APPEAL SUMMARY

Appeal ID: 16583	Project Address: 8316 N Albina Ave
Hearing Date: 3/7/18	Appellant Name: Stephen Korbich
Case No.: B-019	Appellant Phone: 503-750-9367
Appeal Type: Building	Plans Examiner/Inspector: Peter Drake
Project Type: commercial	Stories: 2 Occupancy: F-1 Construction Type: V-B
Building/Business Name: Pot of Gold	Fire Sprinklers: Yes - Whole Building
Appeal Involves: Alteration of an existing structure	LUR or Permit Application No.: 17-254339-CO
Plan Submitted Option: pdf [File 1]	Proposed use: Cannabis Production

Project Name and Address
POT OF GOLD
CANNABIS PRODUCTION AND
PROCESSING FACILITY
8315 N BORTHWICK
PORTLAND, OR 97217

Project Number 8315 BRTWK	Sheet A1
Date 10.06.2017	
Scale VARIES

1 FIRST FLOOR PLAN
SCALE: 1/8" = 1'-0"

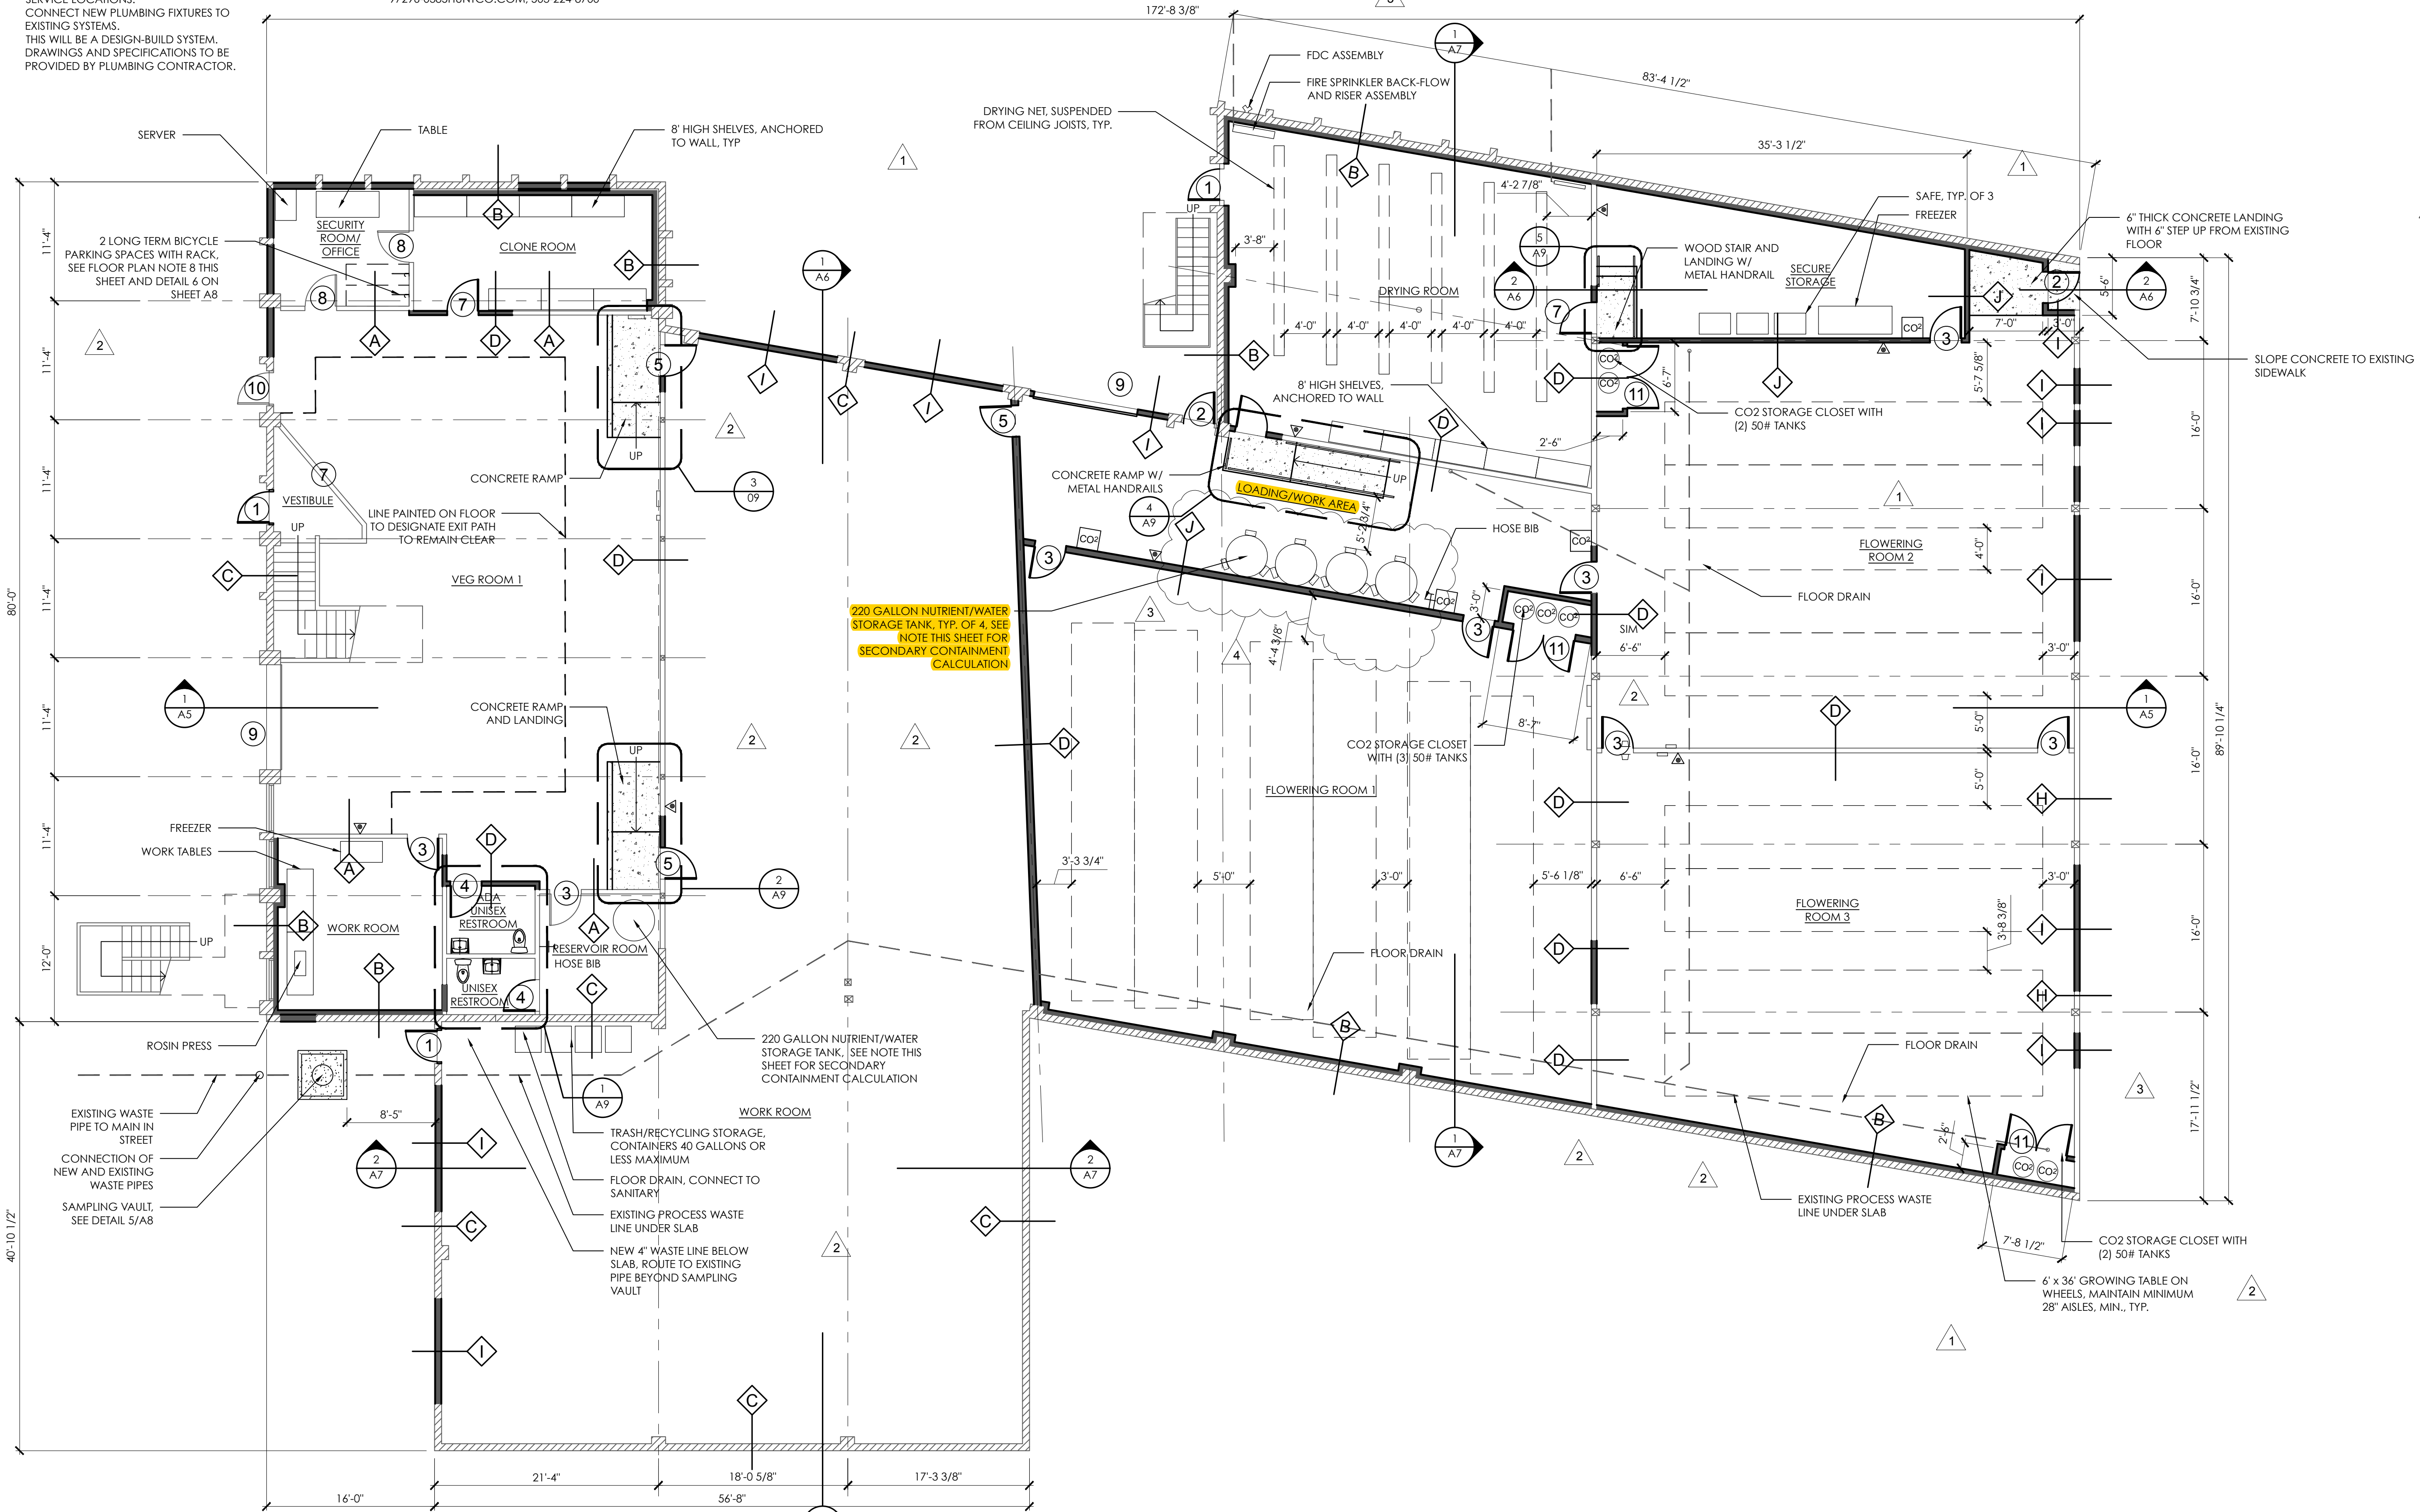
Proposed Design The code official who reviewed this project made the following argument regarding the aisle access at the proposed nutrient (water) tanks shown in the Loading/Work area North of Flower Room 1:

"Aisles and aisle accessways serving as a portion of the exit access in the means of egress shall comply with the requirements with this section. Aisles or aisle accessways shall be provided from all occupied portions of the exit access which contains seats, tables, furnishings, displays and other similar fixtures or equipment. The required width of aisles shall be unobstructed.

Your response was "Aisle dimensions have been added to sheet A1. The water tanks in the loading/work area are locked in place by wood blocks (see detail 3/A8) and will remain at the location indicated in the plans". I don't see in the code that allows wood blocks to be used to isolate tanks in an aisle or accessway.

The wood blocks need to be appealed, or place the tanks in a closet similar to the CO2."

The proposed design shown in the attached floor plan, sheet A1 shows the tanks. Also shown is an aisle greater than 36" as required by 1075.5.

We would like to not build an enclosure (closet) around the tanks as requested by the reviewer.

Reason for alternative Building an enclosure around the tanks does not improve access past the tanks. In fact, the enclosure will reduce the aisle width next to the tanks.

The way the tanks are used in the process would be greatly hindered by building walls and doors here and access to the tanks will be restricted. We believe that this will be more of a hazard than just leaving the tanks secured as shown.

Water tank installation in corridor: Granted provided barriers are installed at each end of the tank area to define an alcove separate from the corridor.
